Autoclass cancellation v110

Change Figure 145–26 as follows:

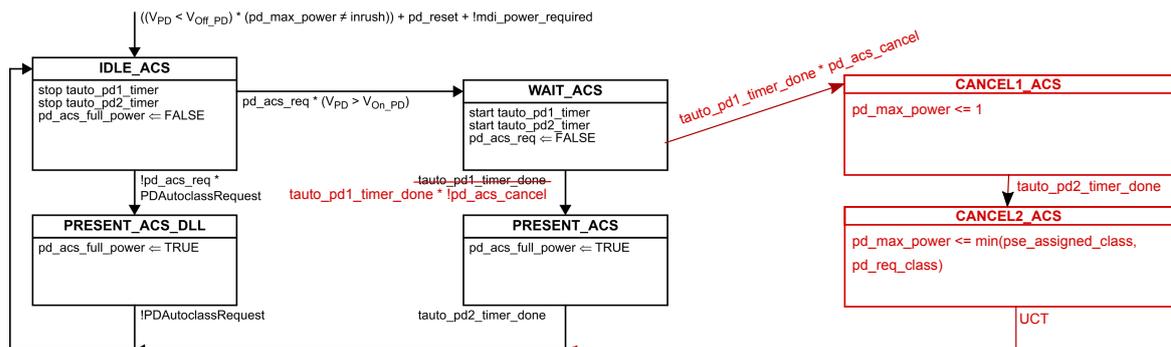
pd_acs_cancel

This variable indicates that the PD wants to abort the Autoclass procedure. See 145.3.6.2.
